Access Compliance Report Public Rights-of-Way (Pedestrian Signals)

Intersection ID: N/A	Main Street:	Cross Street: N/A	Location: N/A
ADA ID: 5B38F38B343C	Signal Type: Two Push Buttons-APS	Overall Compliance: No	Severity Score: BTN 1:N/A BTN 2: N/A No BTN: N/A
Codes/Mitigation Info/Possible Solution		Field Measurements/Component Compliance

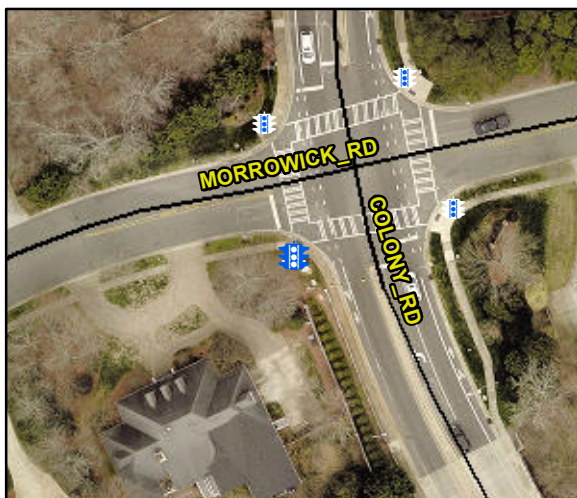
Compliance	Description	Data	Compliance	Description	Data
	Button Count	Button2	N/A	Distant to Additional Button (in)	N/A
	Additional Button Present?	No		Additional Button ID	N/A
N/A	Signal Buttons Required?	N/A	N/A	Additional Ped Posts Required	N/A
	How Many Ped Street Xings?	2		Located In An Island/Median?	No
N/A	B 1 Sign Present?	Yes	N/A	B 2 Sign Present?	Yes
Yes	B 1 Sign Purpose?	Yes	Yes	B 2 Sign Purpose?	Yes
Yes	B 1 Sign Lettering & Contrast?	Yes	Yes	B 2 Sign Lettering & Contrast?	Yes
Yes	B 1 Parallel To XWalk?	Yes	Yes	B 2 Parallel To XWalk?	Yes
Yes	B 1 PAR to Button?	Yes	Yes	B 2 PAR to Button?	Yes
Yes	B 1 PAR to XWalk?	Yes	Yes	B 2 PAR to XWalk?	Yes
Yes	B 1 Clear Floor Space?	Yes	Yes	B 2 Clear Floor Space?	Yes
N/A	B 1 FWD Approach?	Yes	N/A	B 2 FWD Approach?	No
N/A	B 1 FWD Approach Constrained?	No	N/A	B 2 FWD Approach Constrained?	N/A
No	B 1 FWD Approach Reach (in)	6.0	N/A	B 2 FWD Approach Reach (in)	N/A

N/A	B 1 FWD Approach Width (in)	N/A	N/A	B 2 FWD Approach Width (in)	N/A
N/A	B 1 FWD Approach Obstruction?	Yes	N/A	B 2 FWD Approach Obstruction?	N/A
N/A	B 1 FWD Approach Obstruction Dist (in)	2.5	N/A	B 2 FWD Approach ObstructionDist (in)	N/A
N/A	B 1 PARA Approach?	Yes	N/A	B 2 PARA Approach?	Yes
N/A	B 1 PARA Approach Constrained?	No	N/A	B 2 PARA Approach Constrained?	No
Yes	B 1 PARA Approach Reach (in)	6.0	Yes	B 2 PARA Approach Reach (in)	9.0
N/A	B 1 PARA Approach Width (in)	N/A	N/A	B 2 PARA Approach Width (in)	N/A
N/A	B 1 PARA Approach Obstruction?	Yes	N/A	B 2 PARA Approach Obstruction?	Yes
N/A	B 1 PARA Approach Obstruction Dist (in)	2.5	N/A	B 2 PARA Approach ObstructionDist (in)	2.5
Yes	B 1 Clear Floor Space Slope (%)	4.4	Yes	B 2 Clear Floor Space Slope (%)	2.6
No	B 1 Clear Floor Space XSlope (%)	11.4	No	B 2 Clear Floor Space XSlope (%)	11.6
N/A	B 1 PAR Slope (%)	4.8	N/A	B 2 PAR Slope (%)	5.5
Yes	B 1 Height (in)	35.0	Yes	B 2 Height (in)	34.0

Yes	B 1 Clear Xing Direction?	ClearlyMarked	Yes	B 2 Clear Xing Direction?	ClearlyMarked
	B 1 Crossing Direction	To NE		B 2 Crossing Direction	To NW
Yes	B 1 DistanceTo XWalk (in)	24.0	Yes	B 2 DistanceTo XWalk (in)	14.0
No	B 1 DistanceTo Curb (in)	100.0	Yes	B 2 DistanceTo Curb (in)	71.0
Yes	B 1 Diameter (in)	2.0	Yes	B 2 Diameter (in)	2.0

Possible Solutions: Replace Signal Push Button With APS Button on New Post.
Remove & Relocate Sign. Remove & Replace Replace APS Button With New APS Button.
Remove and Replace Clear Space.
